INDEPENDENT ADVISORY
PANEL FOR UNDERGROUND
MINING

**DENDROBIUM EXTENSION
PROJECT**

SSI-33143123

July 2022

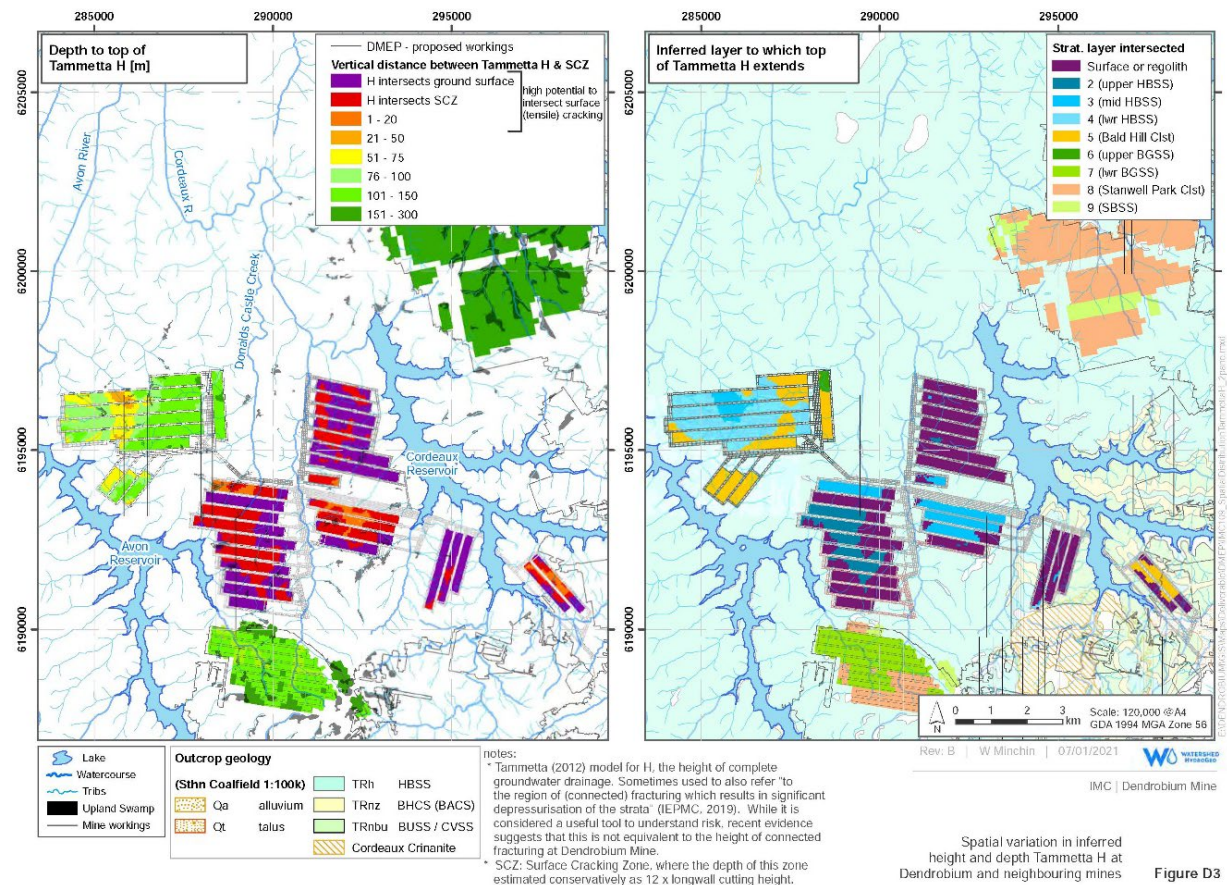
The following figure extracted from the Groundwater Study (Appendix B of the EIS) shows the predicted height of complete groundwater drainage based on the Tammetta Equation.

- Can IMC please provide a suite of figures based on the above figure for longwall panel widths of 150 m, 200 m, 250 m and 305 m and which, additionally, include figures showing the upper and lower bounds (error bands) of predictions based on the Tammetta equation.

Fig. 3.14 Proportion of pools with Type 3 impacts along Drainage Line WC21 in Area 3B

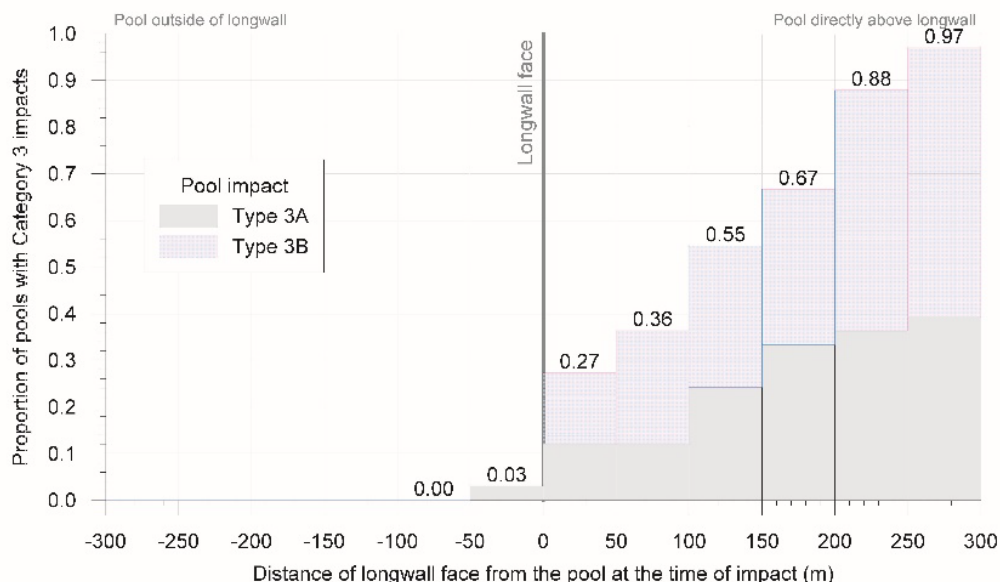
- iv. The figures quoted in the text under the above figure for the percentage of pools experiencing Type 3B impacts appear from the graphic to also include Type 3A impacts; that is, the quoted percentages appear in the graph to be made up of both Type 3A and Type 3B impacts. Please clarify.
- v. Can IMC please provide a tabulation comparing the predictions based on the previous rock bar model with those based on the revised model for the circumstances associated with the revised mine plan for the DME?

Figure 5: Risk Criteria “ALARP”

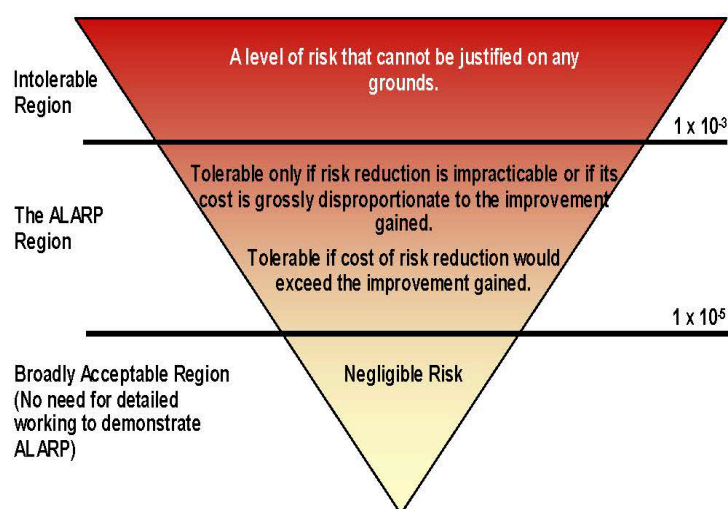
- ix. What do the values ' 1×10^{-3} ' and ' 1×10^{-5} ' correspond to in the above figure?
- x. How do these values relate to ALARP in the preceding risk matrix?
